SERVICE BULLETIN

SERVICE BULLETIN NO: 57-006

WINGS - CENTER WING - INSPECTION AND MODIFICATION OF THE MAIN-SPAR DIHEDRAL FITTINGS

Eddy Current Inspection of the Wing Aft-Dihedral Fittings - Surface and Scan Path Data
 Figure 1

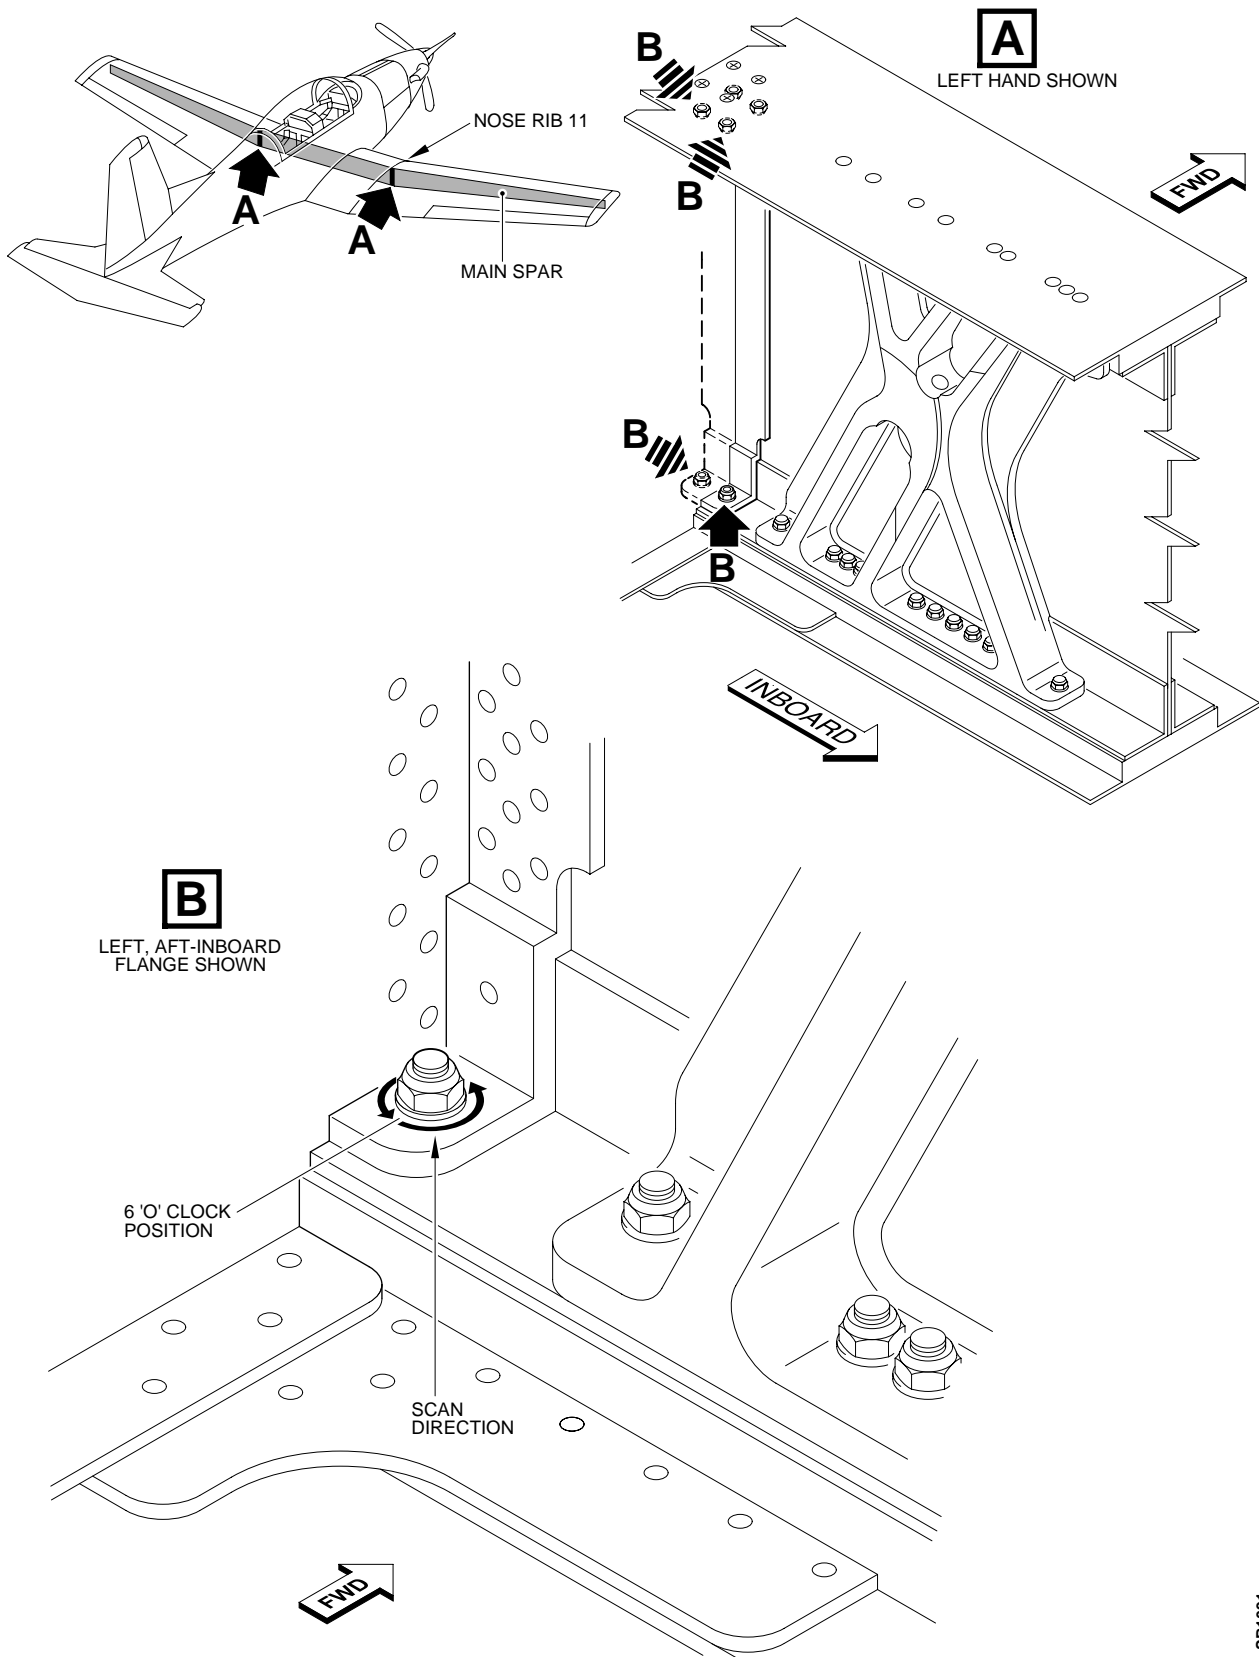
B. Eddy Current Inspection of the Aft Dihedral Fitting Flanges (8 Locations) (Ref. Fig. 1)

- (1) Calibrate the Eddy Current Instrument as follows:
 - (a) Initial gain 35 Db.
 - (b) Frequency 500 KHz.
 - (c) Alarm low OFF.
 - (d) Alarm high 50%.
 - (e) Probe selection Absolute.
- (2) Refer to the manufacturer's handbook and calibrate the instrument for an 80% upscale deflection from the 0.5 mm EDM slot of the calibration standard.
- (3) Put the probe on the inspection surface of the lower inboard flange of the left aft dihedral-fitting. Put the probe so that it touches the washer of the fastener at the 6 o'clock position (Ref. Fig 1, Detail B).
- (4) Do the balance procedure as given in the manufacturer's handbook.
- (5) From the 6 o'clock position, do a scan around the fastener of the bottom flange. Use the washer as guide. Defect indications will show as a fast upscale movement of the indicator.
- (6) Record the results of the inspection (Ref. Para. C).

- (7) Do Steps (3) thru (6) again for a scan of the:
- top inboard flange of the left aft dihedral-fitting
 - upper and lower outboard flanges of the left aft dihedral-fitting.
 - upper and lower, inboard and outboard flanges of the right aft dihedral-fitting.

Eddy Current Inspection of the Wing Aft-Dihedral Fittings - Permitted Crack Damage Area
Figure 2

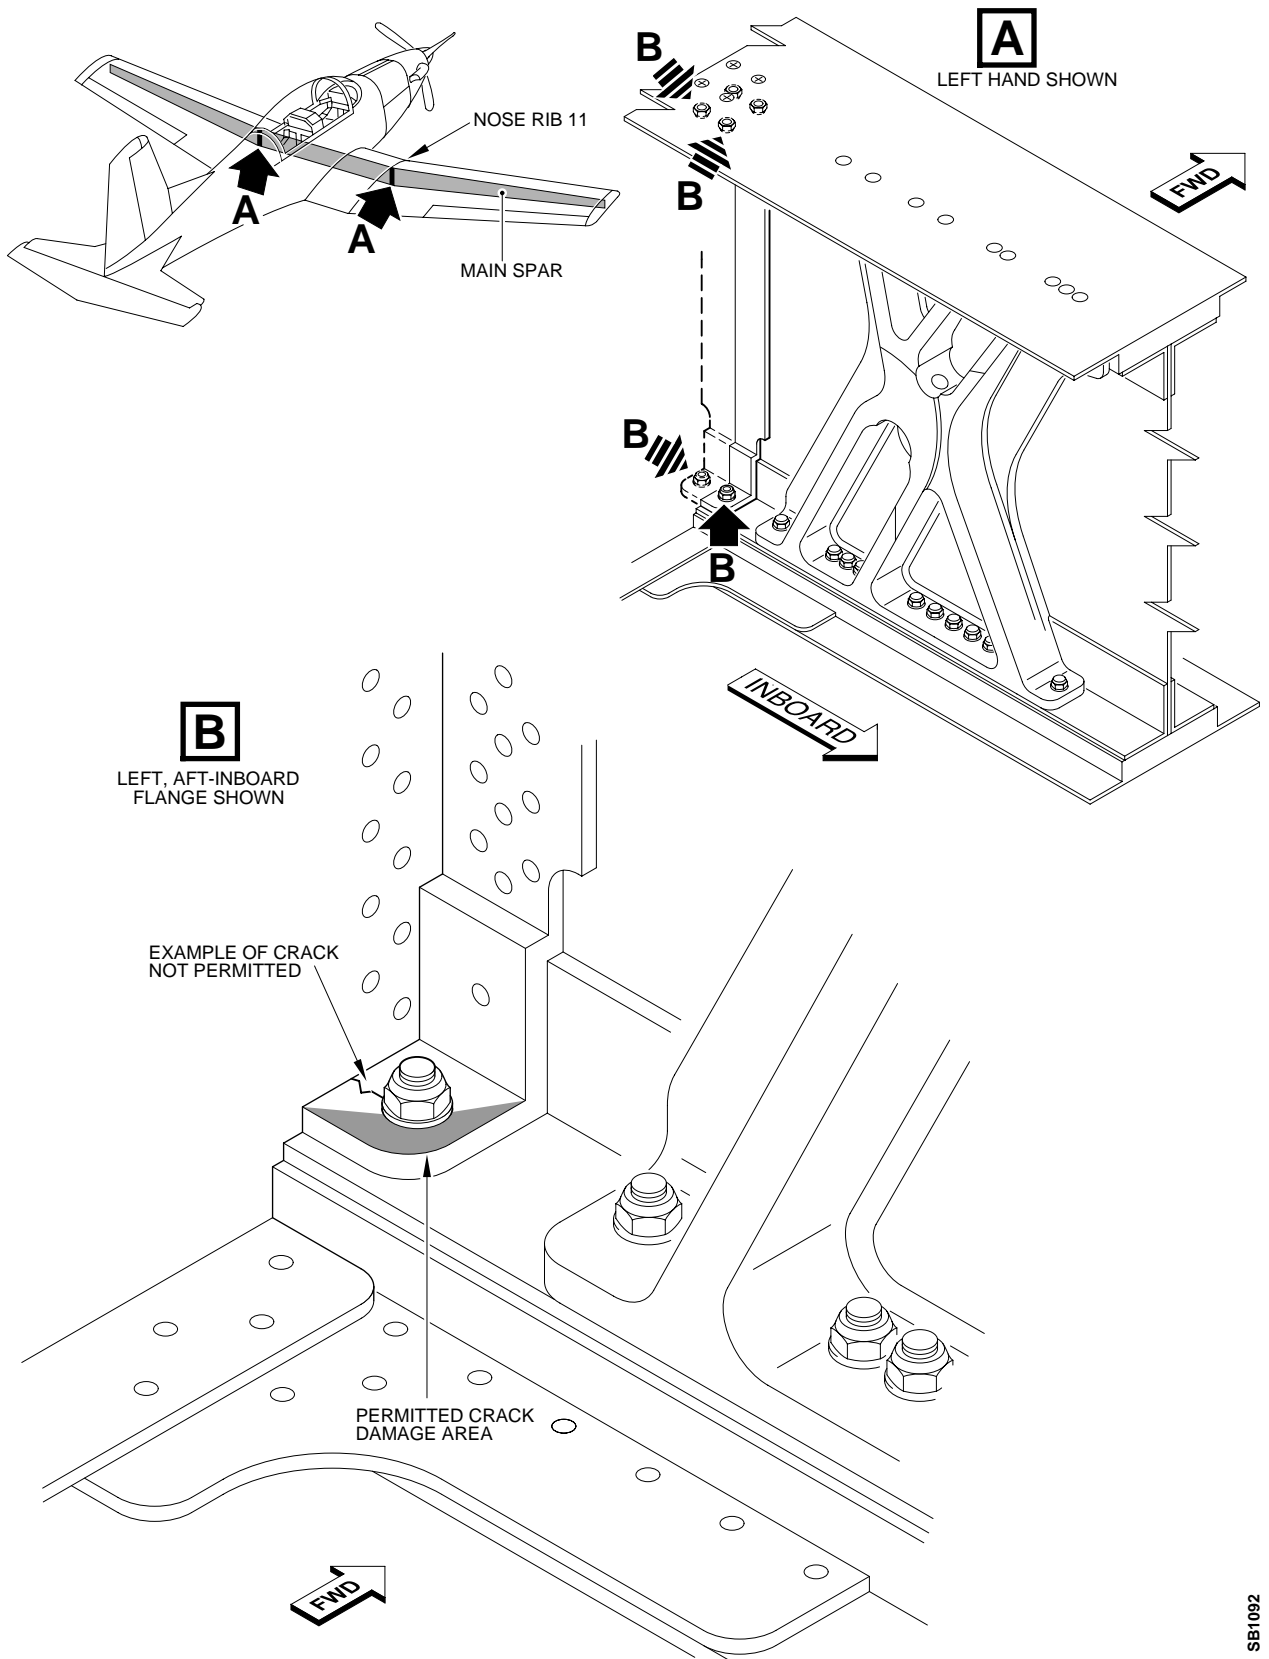
C. Defect Data for Eddy Current Inspection of the Aft Dihedral Flanges (Ref. Fig. 1 and 2)

- (1) A defect indication in a fitting that can be repeated and is not caused by edge effect or part geometry and is not in the permitted-crack-damage area is not permitted.

- (2) If the inspection shows no defects or defect(s) only in the permitted crack-damage area of the aft fittings:
- (a) Make an entry in the Aircraft Logbook that the brackets have had an Impedance-Plane Eddy-Current Inspection.
 - (b) Repeat inspections of the bolt holes are necessary (Ref. AMM 05-10-00, Page Block 1).
- (3) If the inspection shows no defects in all four bolt holes, the aft dihedral-fitting bolt-holes must be modified at the earliest servicing opportunity (Para. D). This modification will prevent the start of stress corrosion cracks. It is not necessary to do repeat inspections of the bolt holes after modification.
- (4) Use the Inspection Report Form (Figure 3) to tell the result of the inspection to PILATUS (Ref. Para.I).

Aft Dihedral Fittings - Modification
Figure 5

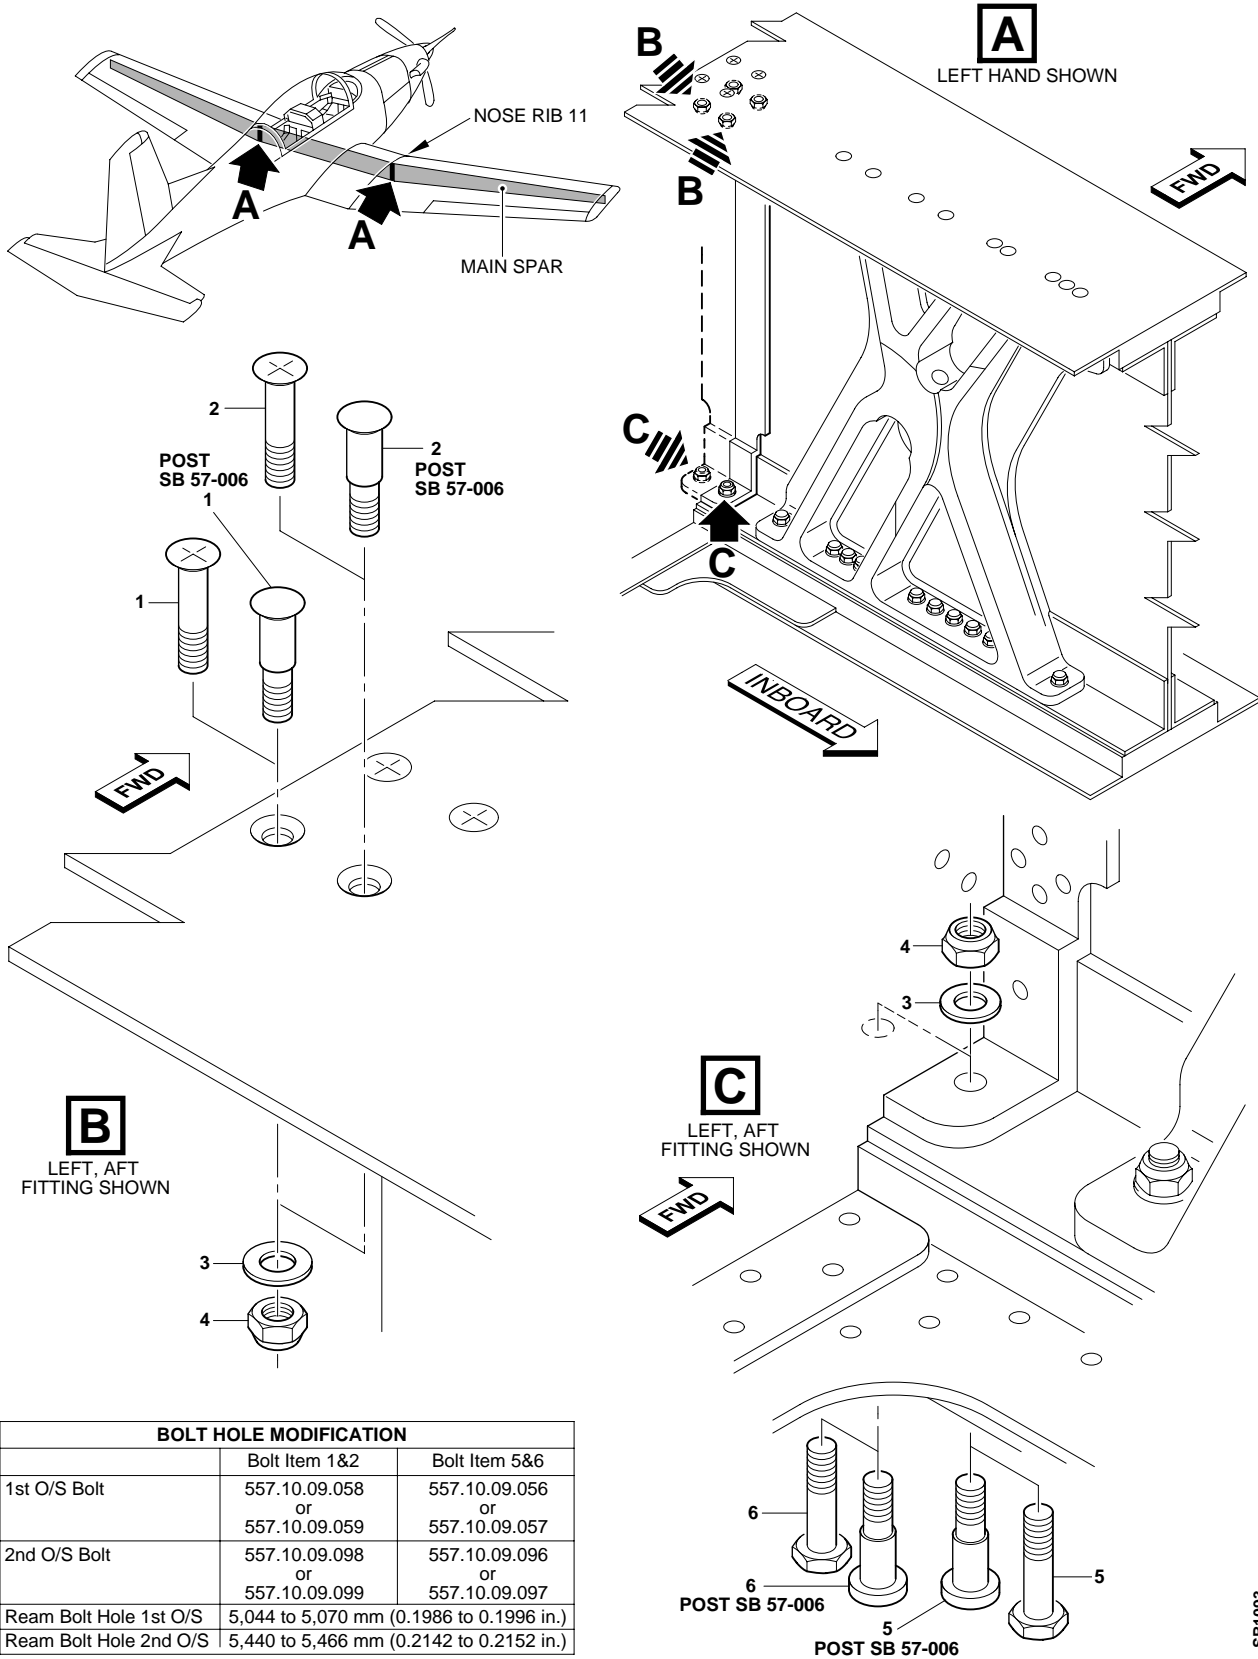
D. Modification of the Aft Dihedral Fitting and Spar-Cap Bolt Holes (Ref. Fig. 5)

Only do this modification to aft dihedral fittings at locations which have no cracks in the flanges. The modification removes high remaining stress from around the bolt holes so that stress corrosion will not start.

This procedure is only applicable to a left and right aft-dihedral fitting in which all four bolt holes (two upper and two lower) have no cracks.

- (c) Use an applicable drift and carefully punch the bolts through the spar and the flange of the dihedral fitting.
- (4) Use the reamer (P/N: 513.57.09.086) to increase the diameter of the bolt holes to between 5,044 and 5,070 mm (0.1986 and 0.1996 in.).

- (7) Measure the grip length of the aft fitting lower-bolt-holes to find which replacement bolt to install
- (a) If the grip length is equal to or greater than 25,2 mm, use bolt P/N: 557.10.09.056.

- (b) If the grip length is less than 25,2 mm, use bolt is P/N: 557.10.09.057.
- (8) If the aft fitting lower-bolt-hole is damaged, install the next oversize bolt

- (9) Measure the grip length of the aft fitting upper-bolt-holes to find which replacement bolt to install
 - (a) If the grip length is equal to or less than 27,0 mm, use bolt P/N: 557.10.09.058.

- (b) If the grip length is greater than 27,0 mm, use bolt P/N: 557.10.09.059.
- (10) If the aft fitting upper-bolt-hole is damaged, install the next oversize bolt

- (13) Install the new washers (3) and nuts (4). Torque the nuts (4) to between 4,0 and 5,0 Nm (35 to 45 lbf in.).
- (14) Clean unwanted sealant from the bolt head, nut and washer.

Eddy Current Inspection of the Wing Aft-Dihedral-Fitting Bolt-Holes - Scan Path Data
Figure 6

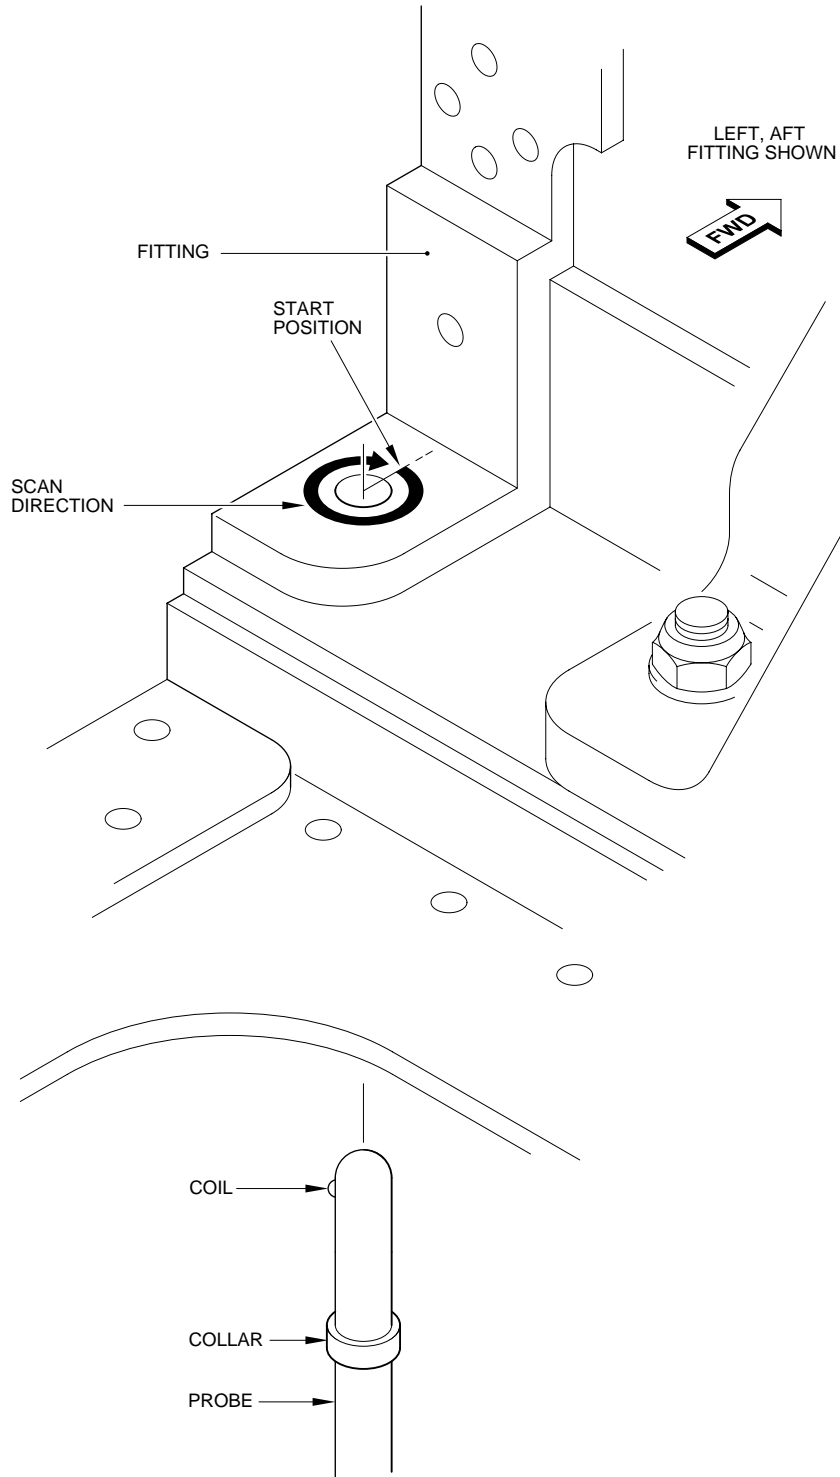
E. Eddy Current Inspection of the Aft-Dihedral-Fitting Bolt Holes (Ref. Fig. 6)

This procedure is applicable to the 4 bolt holes in each fitting, which were reamed out in Para. D.

- (3) Put the probe inside one of the holes in the aft flange of the dihedral fitting.
- (4) Point the coil of the probe forward. Push the probe slowly down the hole and monitor for defect indications. A defect indication will be given at each material interface.

- (10) Carefully turn the probe in the hole. Make sure the probe stays normal to the aircraft wing surface and do a scan around the bolt hole. Defect indications will show as a fast upscale movement of the indicator. Defect indications will normally be across the wing span.

Forward dihedral Fitting - X-ray Inspection Areas and Beam Position
 Figure 7

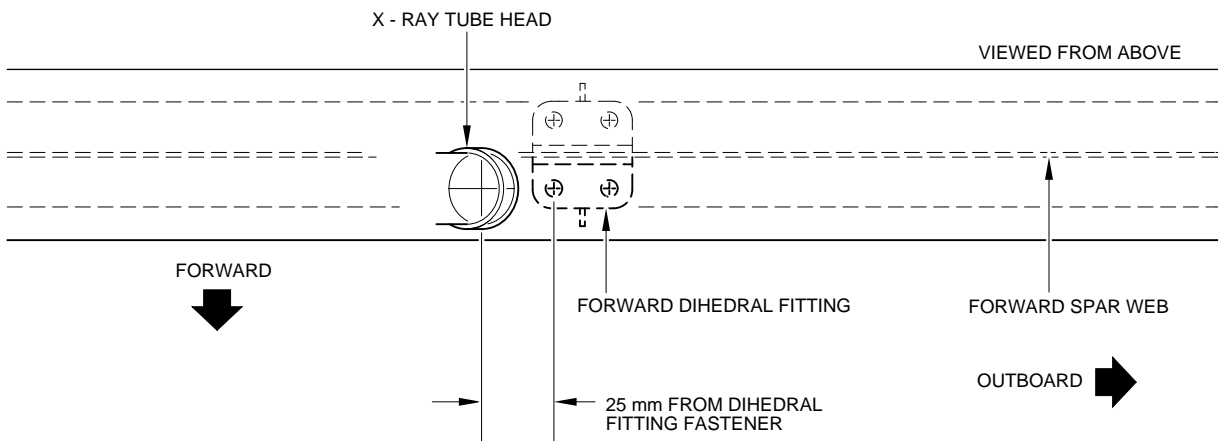
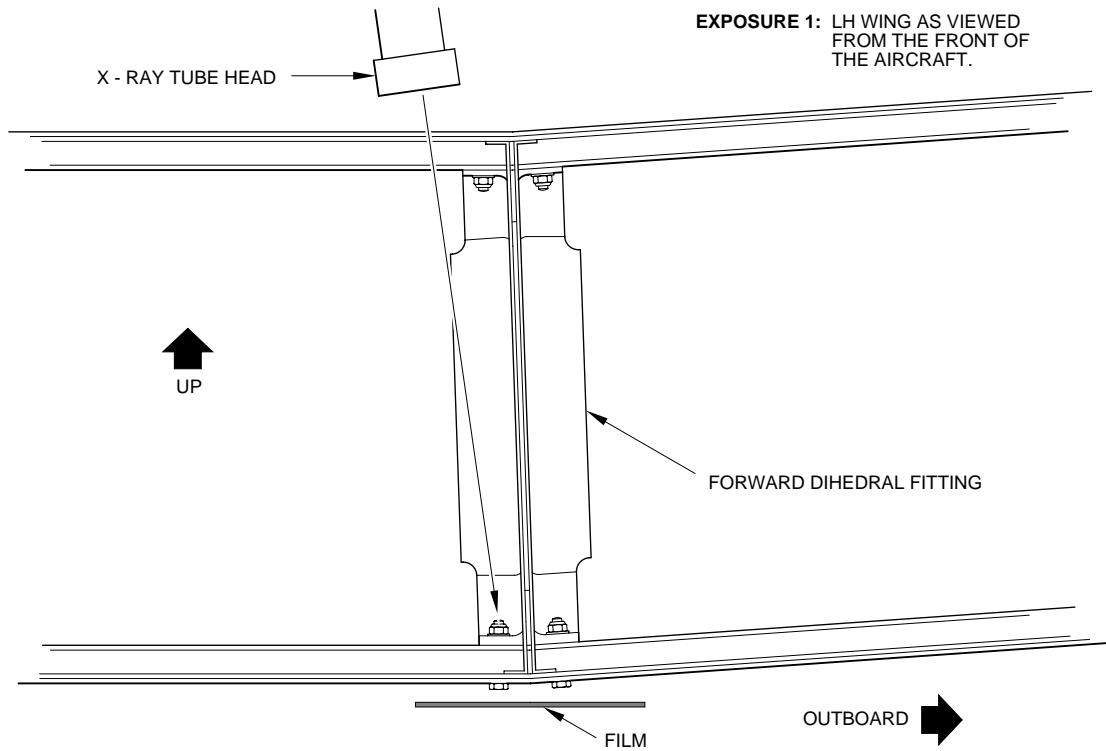
G. Radiographic Inspection of the Forward Dihedral Fittings (Ref. Fig. 7)

- (1) Set the safety barriers around the aircraft (Refer to Manufacturers Instructions and local instructions).
- (2) Put the X-ray equipment in position on the aircraft. Align the X-ray tubehead against the wing, so that it is 25 mm from the forward-dihedral-bracket fastener in the direction of the span.
- (3) Make sure there are no personnel in the radiographic danger area.
- (4) Use the Exposure Table 1 to expose the films, to get a density of between 1.5 and 2.5 adjacent to the fastener to be inspected.
